Ranger Regiment Systems Architecture Version 1.0 Analysis

19 February 2002

**Analysis Branch, TRADOC Architecture Integration and Processing Center,
US Army Signal Center**

Ranger Regiment Systems Architecture

Figure 4.1 RANGER RGT LOG SYS SPT

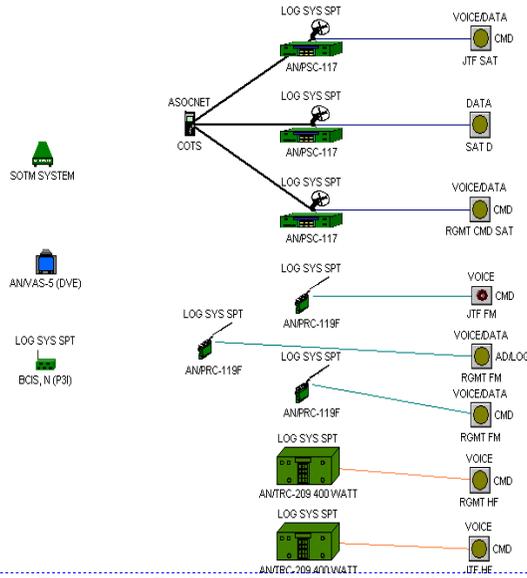
- ONN: 2ZZ00IJ300, RTO GATEWAY/RTO
No IERs for OPFAC IJ300
- ONN: 9ZZ01IJ300, RTO GATEWAY
No IERs for OPFAC IJ300
- ONN: 1QA00I5DZ0, RANGER RGT LOG SYS SPT
Only two Data IERs for OPFAC I5DZ0 support the requirement depicted in figure 4.1.

Figure 4.3 RANGER RGMT FWD COMM BASE

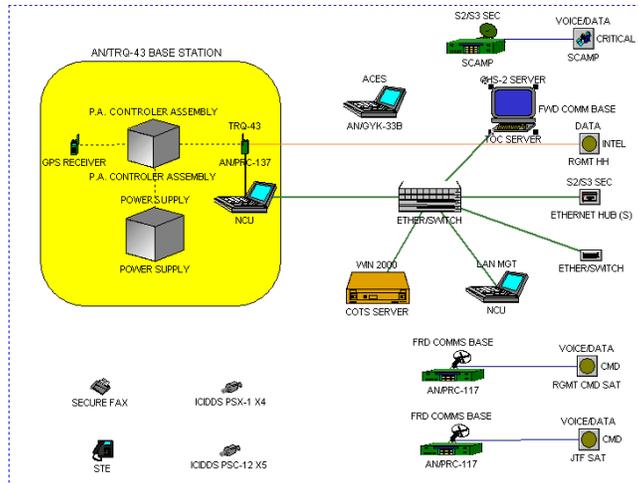
- ONN: 1ZZ00I5181 RANGER RGMT FWD COMM BASE
Only two Voice IERs for OPFAC I5181. However, no Data IERs support the requirement depicted in figure 4.3.

Figure 4.4 MEDICAL TREATMENT SQD

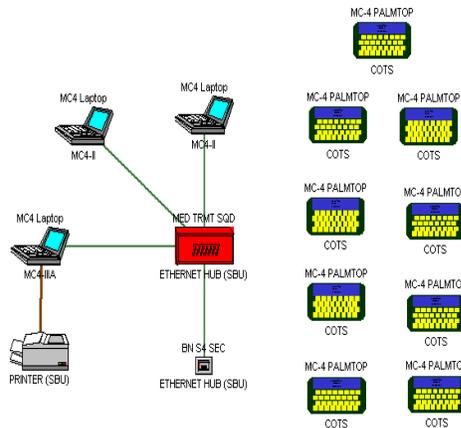
- ONN: 1ZZ00IGTR0, MEDICAL TREATMENT SQD
Only one Voice IER for OPFAC IGTR0. However, no Data IERs support the requirement depicted in figure 4.4.
